12. COA-050743-2019

101 North 29th Street

Commission of
Architectural Review

STAFF REPORT

Figure 13. Previously approved elevation with faux railing on the second story, original connector between house and porch enclosure, and garage elevation. The rear elevation second story porch and the partial brick parapet wall on the garage were not approved.

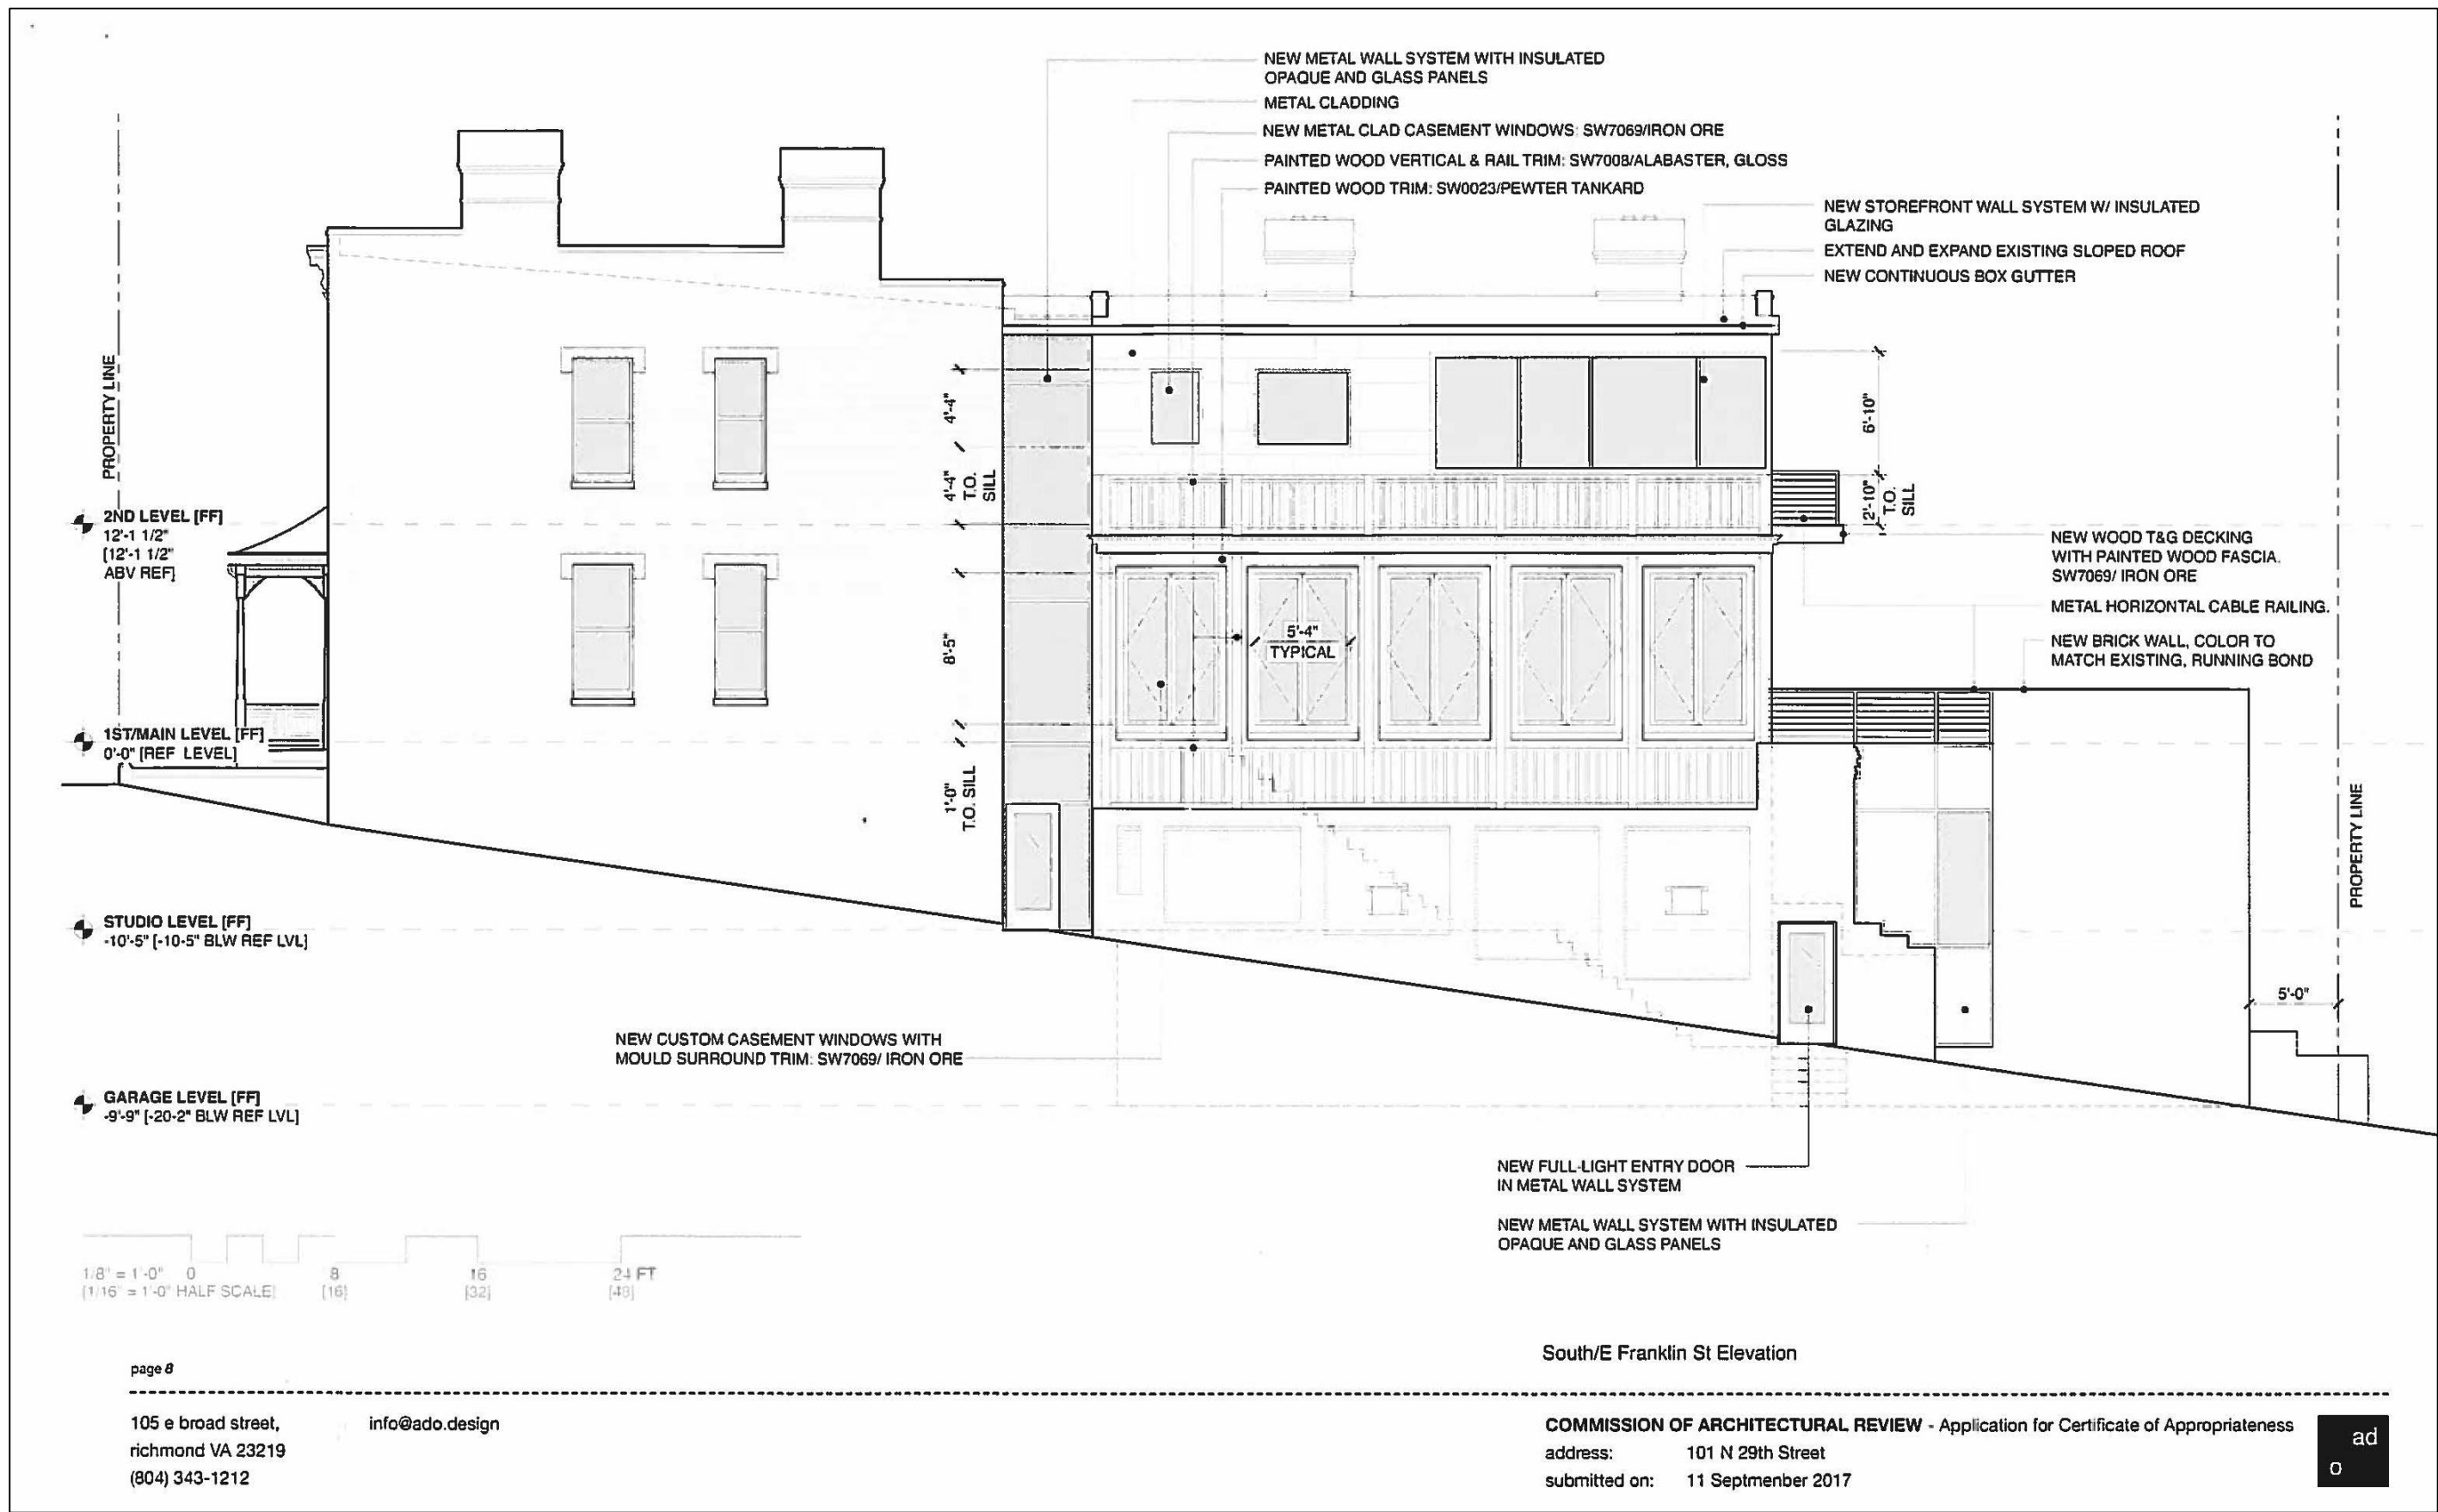
Staff recommends that a horizontal design element below the window sills be included on the second floor East Franklin Street elevation to reference the previously extant railing. Staff finds that this element references the evolution of the building with a two-story porch indicated on the early Sanborn maps, and the ca. 1979 conversion to a porch, without creating a false history.

Staff acknowledges that the height of the historic two-story garage has changed over time, in part due to deterioration after a car hit it. Staff recommends that, in order to maintain the historic relationship and proportions between the house and the garage, the parapet wall be the same height as the first-story faux railing. Staff notes that the applicant did not provide dimensions on the elevation and requests that the revised elevations have dimensions and be submitted for staff review and approval.

- Change in fenestration size of the first story porch enclosure windows, with the condition that the applicant work with staff to add additional glazing or raise the level of the faux railing to meet the window sill.
- Relocation of the door and a solid wall on the garage addition with the condition that the door specifications be submitted to staff for review and approval.
- The new awning on the rear elevation, with the condition that it be mounted directly into the mortar joints, not the historic masonry.
- Removal of the railing on the second story, with the condition that a horizontal design element, such as metal trim to match the vertical trim between the existing and new brick, be placed below the window sills on the second story East Franklin Street elevation.

- A brick parapet wall on the garage addition at the same height as the revised first floor faux railing.
- The vertical trim piece between the historic and new construction, with the details to be submitted to staff for review and approval.
